Your ref: SSD-29668067
File no: MC-22-00003

SSD-29668067 - Request for advice re: South Street Warehousing Estate – at 311 South Street, Marsden Park

Blacktown City Council's submission to SSD 29668067- South Street Warehousing Estate – at 311 South Street, Marsden Park

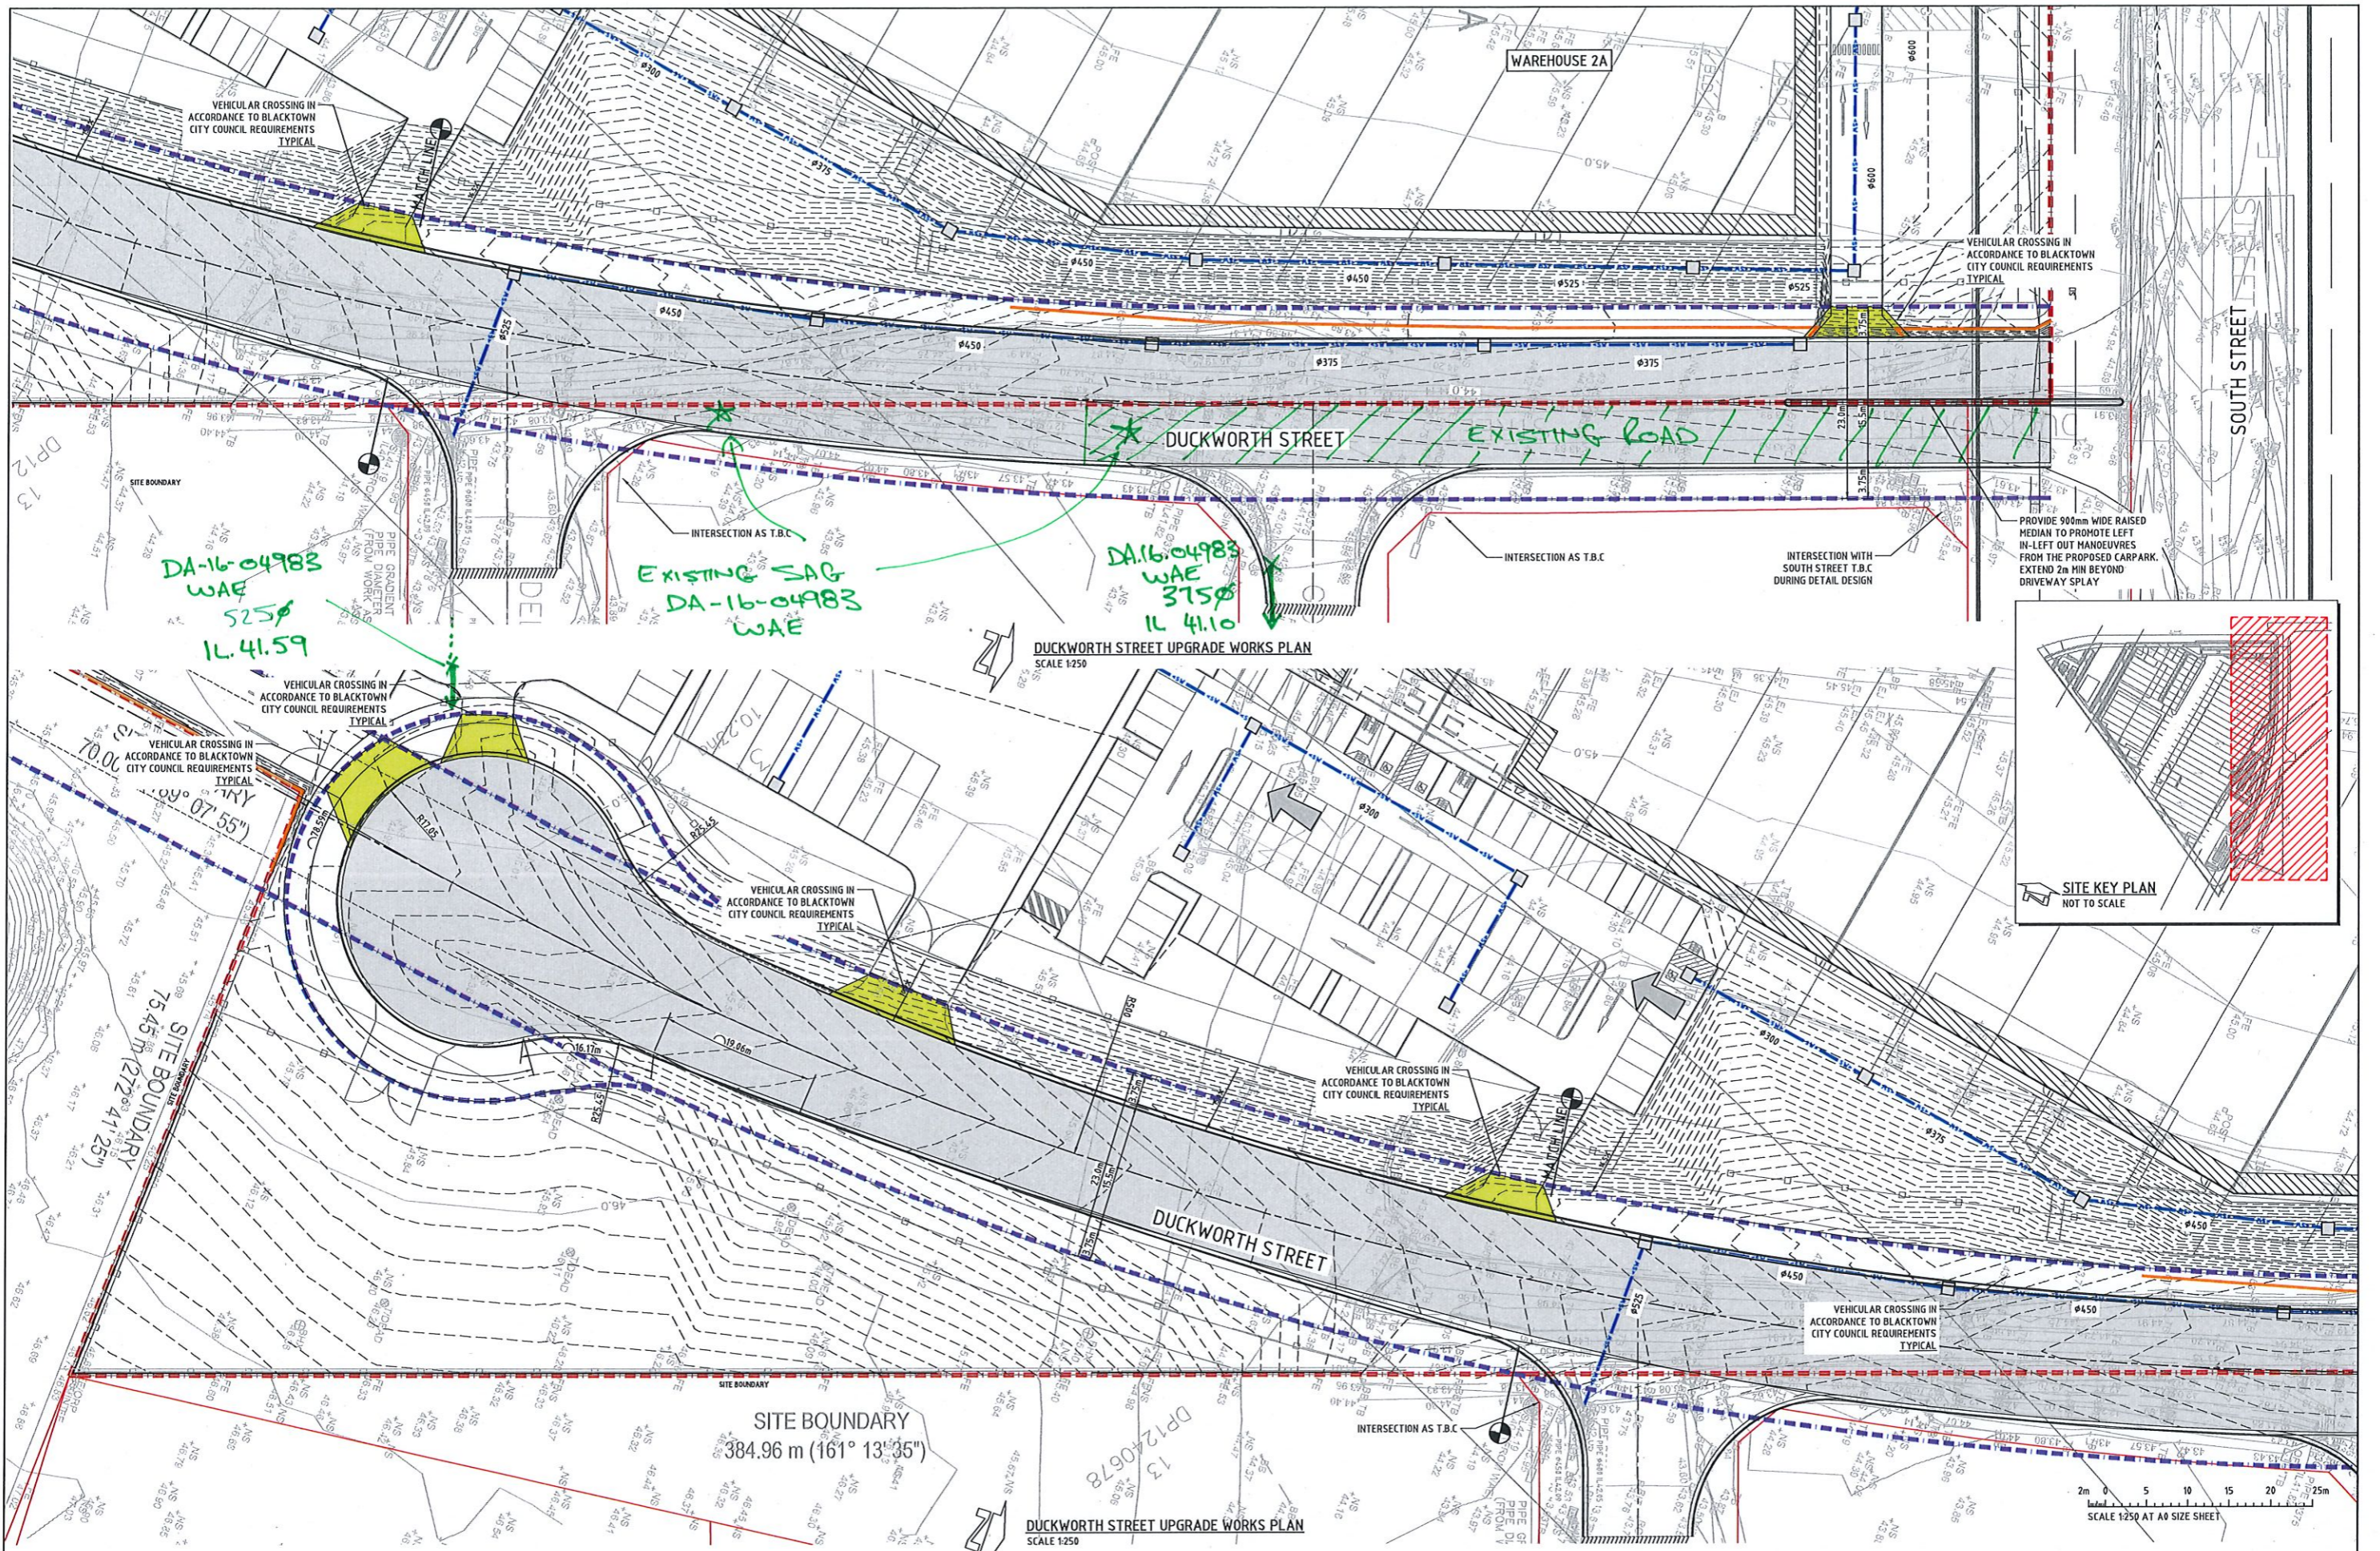
- Trunk Drainage 3600x900 RCBC is to be extended at 1% minimum grade to allow connection for proposed 1350dia pipe (approximate invert 35.25). Existing 825dia pipe and headwall are to be removed. Temporary head wall is to be constructed to match culvert invert.
- Proposed 1350dia pipe must be must comply with minimum cover requirements in accordance with *Blacktown City Council-Engineering Guide for Development* for both existing and ultimate South Street configurations.
- Approximate Tail water levels at proposed pit 6 should be:
 - 50%AEP RL 35.75
 - 20%AEP RL 36.35
 - 10%AEP RL 36.60
 - 5% AEP RL 36.95
 - 1%AEP RL 37.15

- Proposed pits (Pit1 – Pit6) shall allow for future extension to match future South Street road levels
- Proposed 1350dia pipe to have sufficient clearance from 132Kv feeder. Transgrid approval will be required

WAREHOUSE RETAINING WALL PLAN
 SCALE 1:750

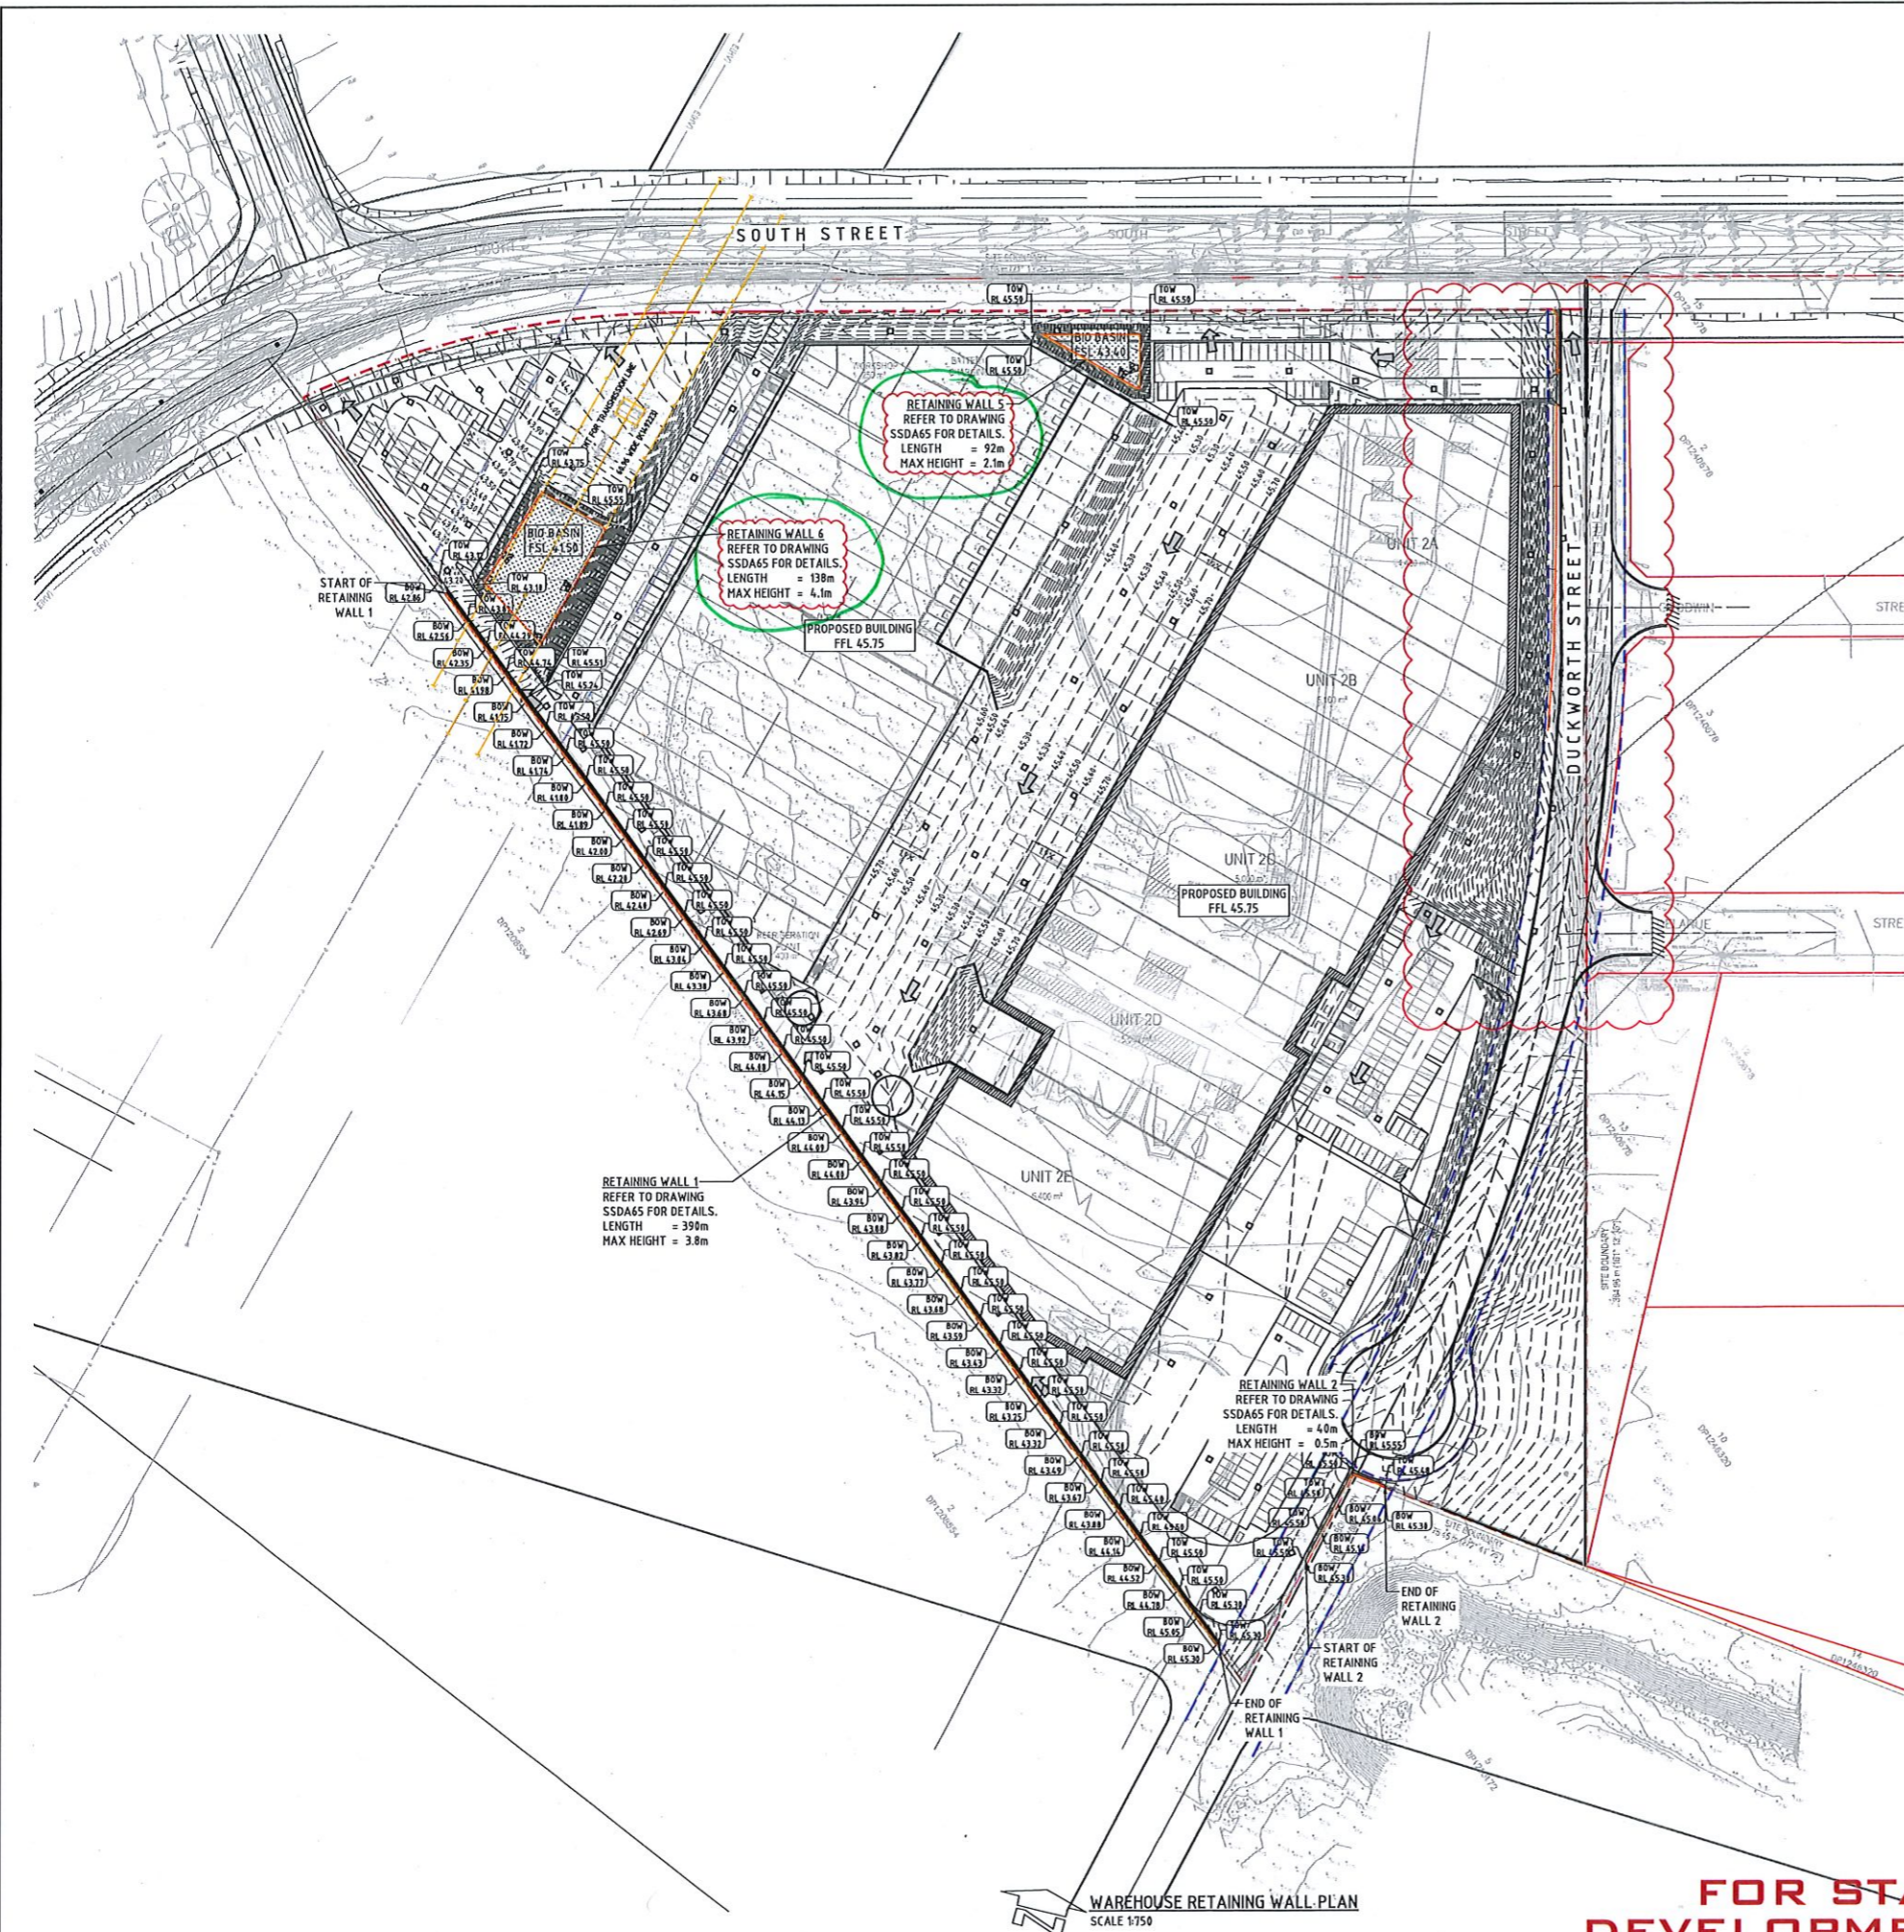
- Proposed Bioretention basin retaining wall heights (4.1m high max) are inconsistent with details (2.0m high max)
- Proposed construction is within TransGrid Easement. TransGrid approval will be required

RETAINING WALL
(BIO-RETENTION BASIN BOULDER RETAINING WALL)
SCALE 1:20

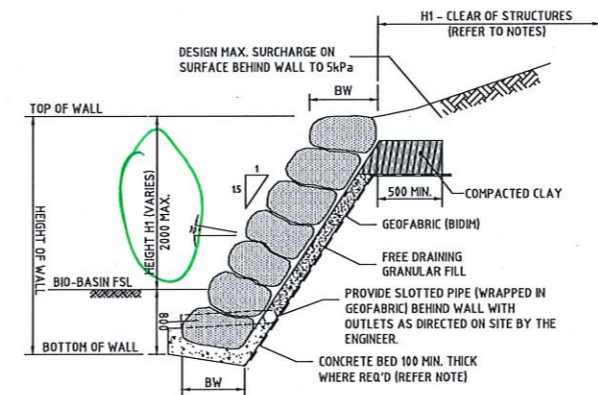
- h. Height details of the retaining walls shall be revised to be consistent between the plan drawings and section details.
- i. Bio-retention basins will require access ramps for maintenance and repair inside the basin. As such, suitable access ramps for servicing vehicles will need to be provided. These shall be designed in accordance with AS2890 part 2 for the largest service vehicle.
